ADA Curb Ramp New Construction Inspection Form (Combination)

NW 307th

23886.56

NW Pacific

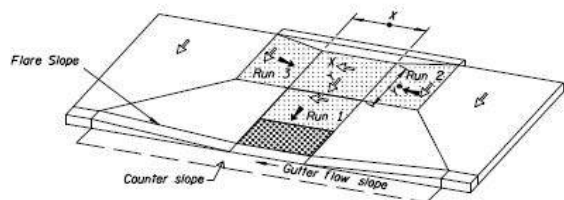
Longest distance from detectable warning corner to back of curb (to nearest inch)

Detectable warning extends full width of ramp throat opening

TD not full width, more than 2", RR3-CRK
